FPL Energy
Seabrook Station

NYN-03049

Seabrook Station
Response to Request for Information
Regarding License Amendment Requests 02-06 and 02-07

ENCLOSURE 1 TO NYN-03049

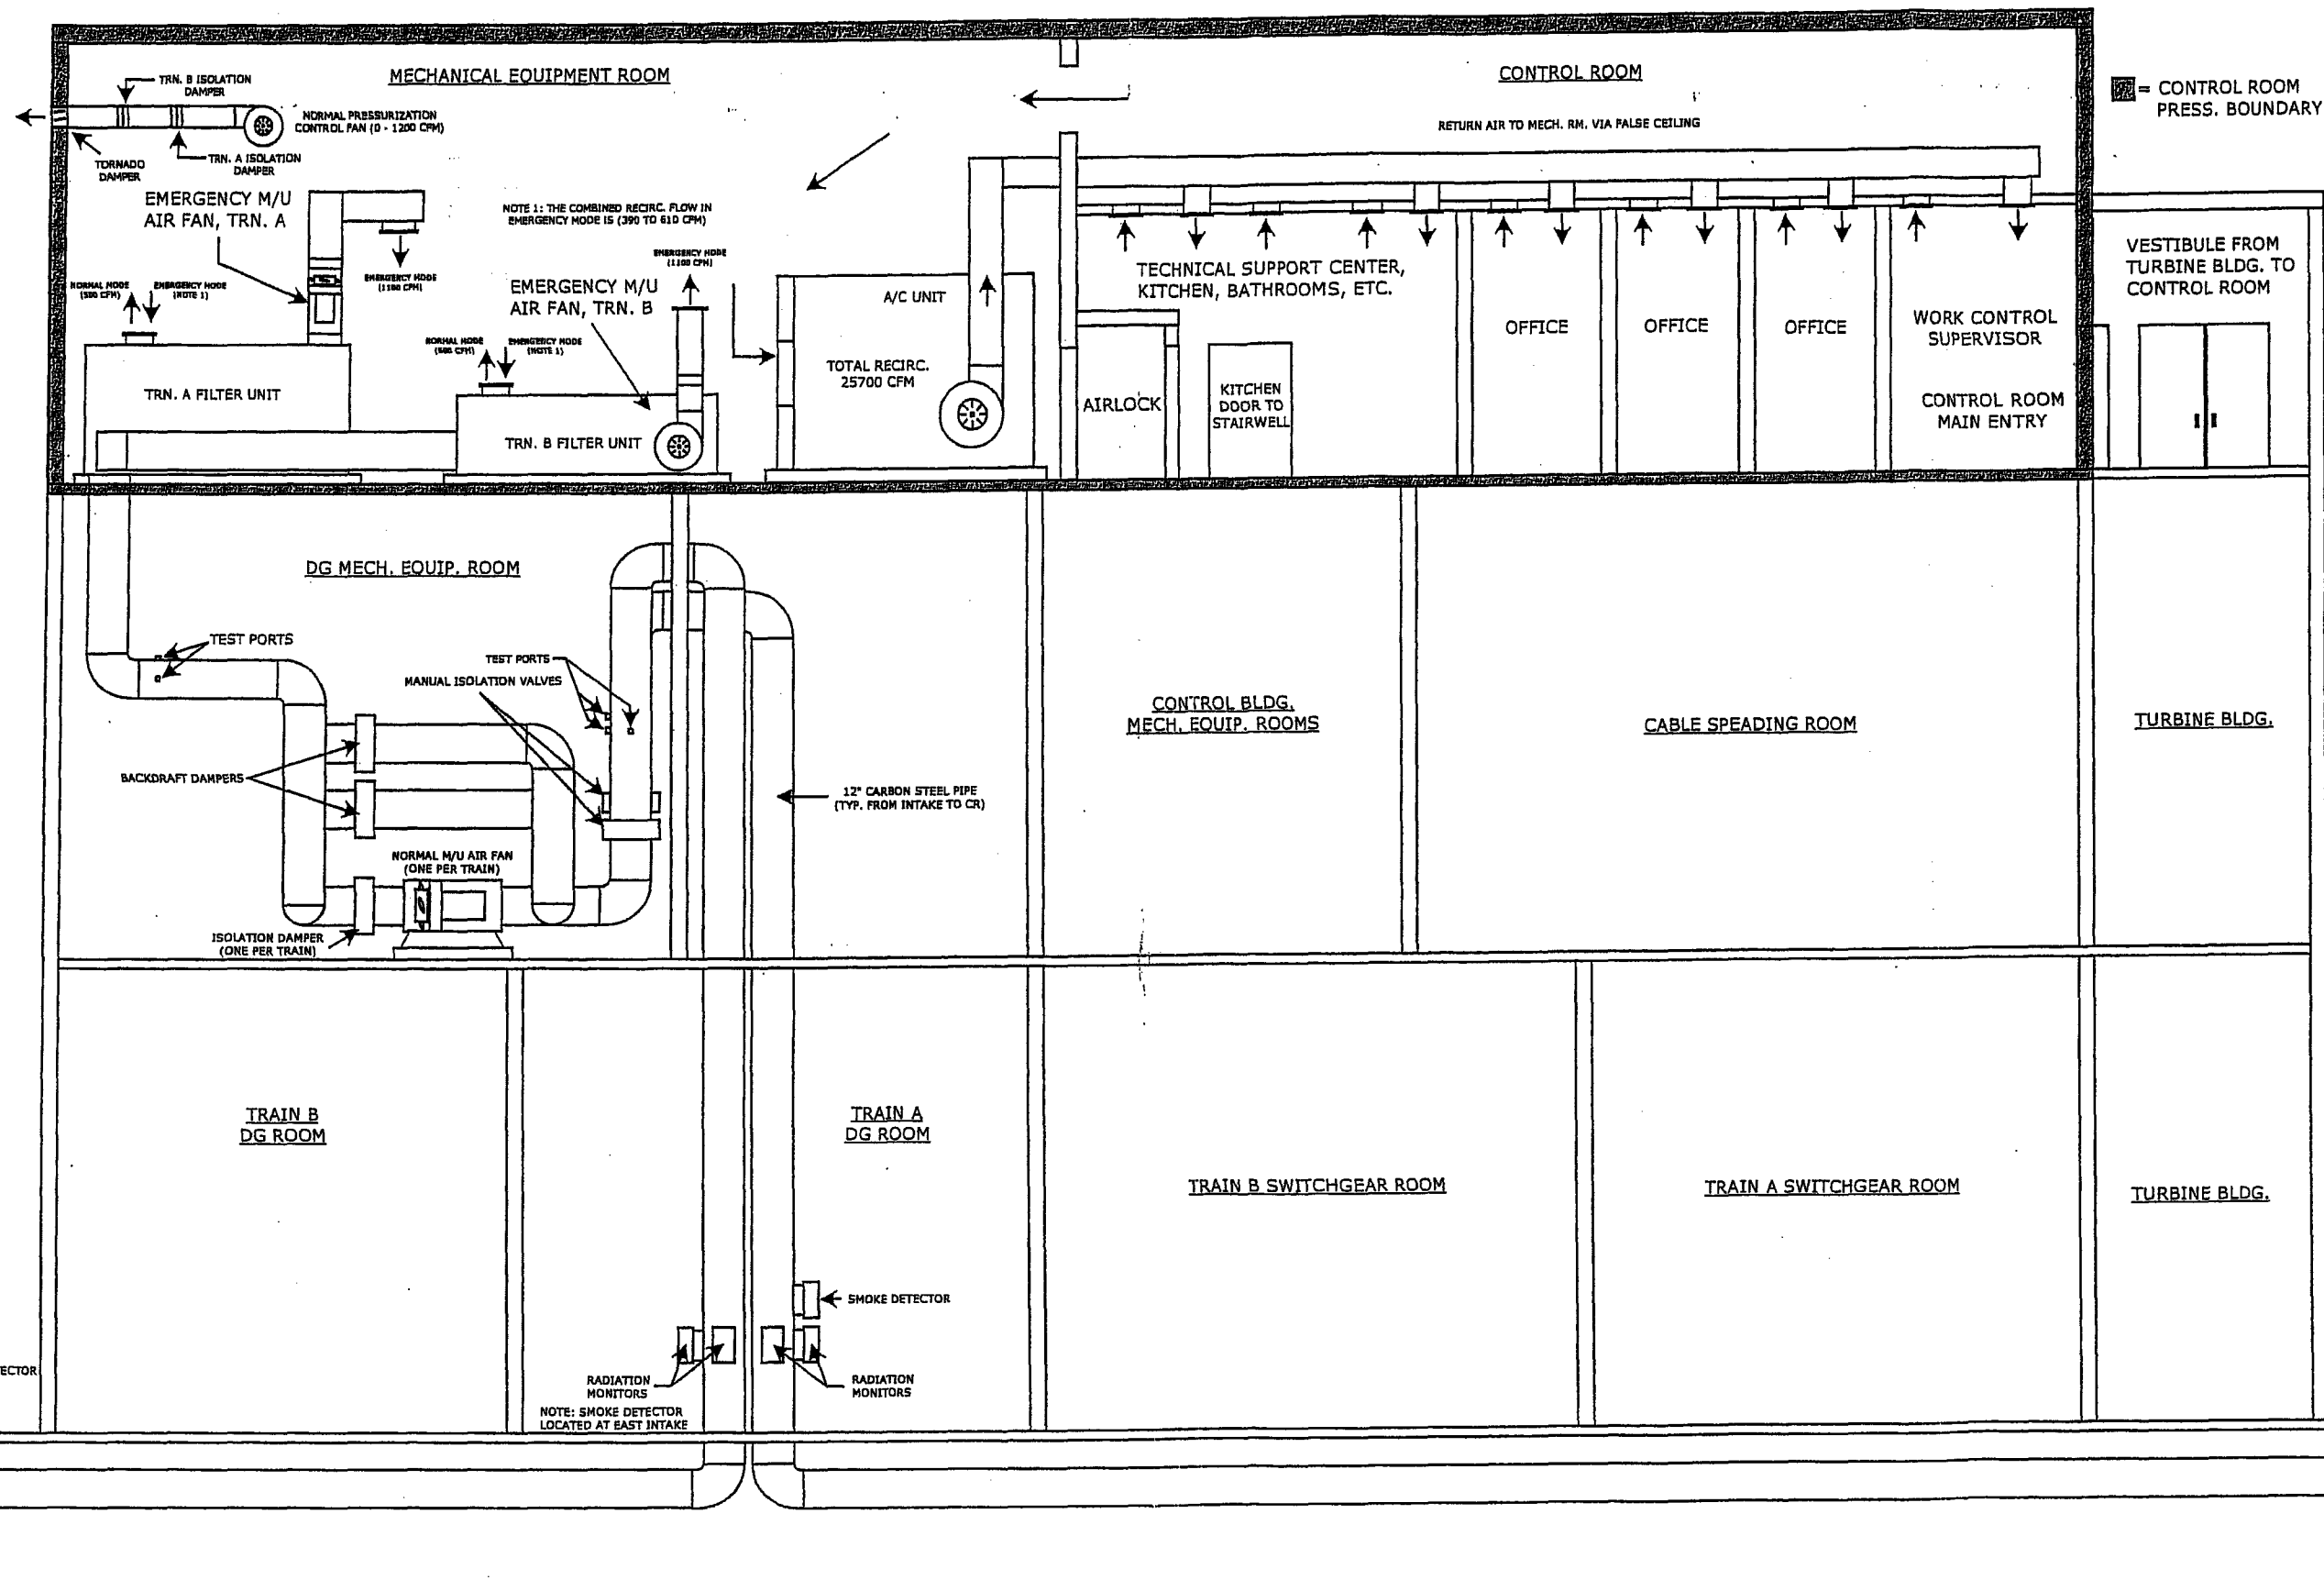
2. *LAR 02-07, "Changes to TS 3.9.4, Containment Building Penetrations," dated October 11, 2002, also refers to the revised FHA dose analyses as discussed in the submittal letter for LAR 02-06 as well as the current UFSAR Chapter 15.7.4 FHA dose analyses. The current UFSAR FHA dose analyses use atmospheric dispersion factors (X/Qs) for the control room dose calculation that are based on radioactivity release due to containment leakage. Seabrook UFSAR Appendix 15B documents that these X/Qs were determined based on Equation 6 of Murphy and Campe (Ref. 1) which is applicable to a diffuse source with a point receptor. Since the equipment hatch/proposed containment outage door is a much smaller release area than the entire containment building, how do these control room X/Qs remain acceptable for use for the case where the containment is open to the outside environment?*

Atmospheric dispersion factors (χ/Q values) for two source-receptor combinations were used to evaluate Control Room doses: Equipment Hatch/Personnel Airlock leakage to the Control Room building and Equipment Hatch/Personnel Airlock leakage to the two Control Room remote air intakes. The use of Equation 6 of Murphy and Campe to model both these source-receptor combinations is justified as follows.

The Equipment Hatch/Personnel Airlock leakage to the Control Room Building represents a release to a volume receptor, where the volume receptor is exemplified by the isolated Control Room with infiltration occurring at many locations. Murphy and Campe state that the use of Equation 6 is appropriate for this case. The resulting χ/Q values were used to assess the 1 cfm infiltration contribution to the Control Room dose.

The Equipment Hatch/Personnel Airlock leakage to the two remote air intakes represents a release to a dual air inlet design. Section III.3.d(4) of Standard Review Plan (NUREG-0800) Chapter 6.4 states that Equation 6 of Murphy and Campe may be used with respect to the least favorable inlet location to estimate χ/Q values for dual inlet designs without manual or automatic selection control. The estimated value can then be reduced by a factor of two to account for dilution effects associated with a dual inlet configuration. This approach was used to derive the χ/Q values for the two remote air intakes which were assumed to be functional during the duration of the accident.

As further justification for the use of Murphy/Campe Equation 6, a new set of atmospheric dispersion factors were calculated using ARCON96, along with the following:

- (a) Five years' worth of hourly meteorological data collected on site (1998-2002),
- (b) Representation as point-release to point-receptor geometries for releases from the personnel hatch to the various control room intakes, with no initial values assigned to the dispersion coefficients (σ_y and σ_z), and
- (c) No building wake effects (an overly conservative assumption).

Comparison of the (χ/Q)s is presented in the table which follows. It is seen that, in general, the ARCON96 dispersion values are lower, with only a single exception, the Local Intake (χ/Q) from 2 to 8 hrs. The composite (χ/Q)s are lower during all time intervals.

An overall evaluation of the conservatism associated with use of the Murphy/Campe Eq. 6 was arrived at by recalculating the CR doses for the FHA with open containment using the ARCON96 (χ/Q)s in the above table. The calculated thyroid dose is 3.03 rem, a factor of 2.44 lower than the 7.38 rem (the calculation of record).
